ATTACHMENT 1

Responses to NRC Requests for Additional Information (RAIs) on PWROG-18034-P, Rev. 0 (Non-Proprietary Version)

Markups to PWROG-18034-P / PWROG-18034-NP that Reflect the Changes Discussed in the RAI Responses (Non-Proprietary Version)

RAI 5 Figure 1: Comparison of Strain Energy for Linear-Elastic and Elastic-Plastic Material Models

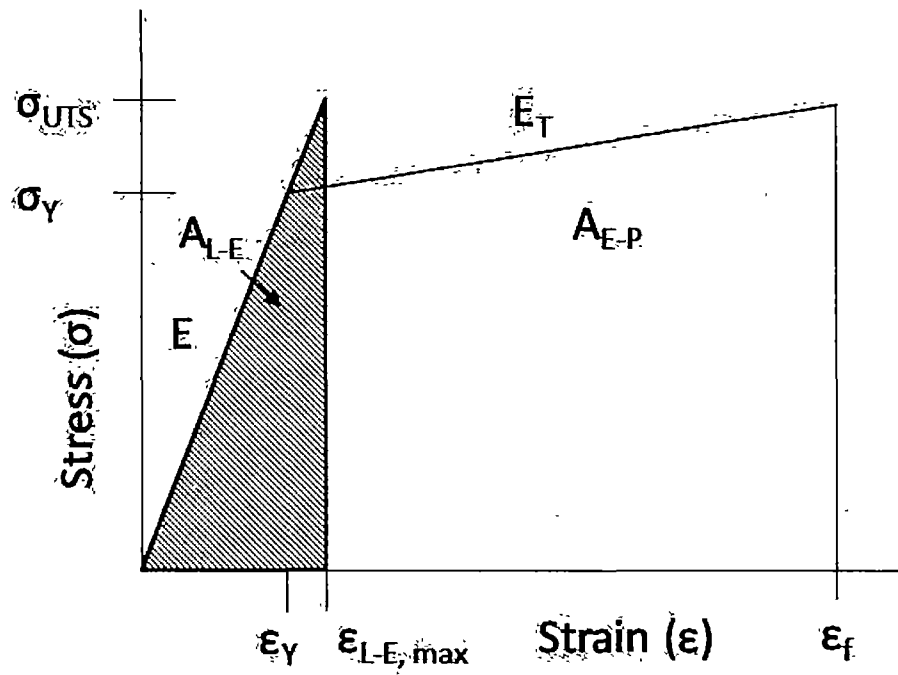
The staff notes that the bounding irradiated bolt properties of [[]], when used with Option 2 for elastic analysis, result in a higher allowable total primary stress (primary membrane stress (P_m) + primary bending stress (P_b)) than either Option 2 or Option 3 for elastic-plastic analysis, as shown in the table below:

It seems that elastic-plastic analysis should result in higher allowable $P_m + P_b$ than elastic analysis.

Justify why the $P_m + P_b$ equation from F-1440 c(1) can be used for irradiated bolts with the bounding material properties; e.g., why is it acceptable for elastic analysis to result in a higher allowable $P_m + P_b$ than elastic-plastic analysis?

It is agreed that the allowable stress is higher for linear-elastic Option 2 relative to elastic-plastic Option 2. However, the strain energy, as determined from the area under the stress strain curve, for linear-elastic Option 2 is a small fraction of that for elastic-plastic Option 2. Therefore, linear-elastic Option 2 is significantly bounding.

For example, consider a material model for stainless steel with an elastic modulus of 25,300 ksi at 600°F, a yield strength of []^(a,b,c), an ultimate strength of []^(a,b,c), and a failure strain of []^(a,b,c) (consistent with the material properties in Table 2 of PWROG-18034-P) where the applicable stress strain curve for the linear-elastic and elastic-plastic material models are shown in RAI 5 Figure 1.

$$A_{ratio} = \frac{A_{L-E}}{A_{E-P}} = \left[\right]^{(a,b,c)} = 0.0273$$

The area under the stress-strain curve for the linear-elastic material model is less than 3% of the elastic-plastic material model. Therefore, it is demonstrated that the strain energy for the elastic-plastic material model substantially bounds the linear-elastic material model.
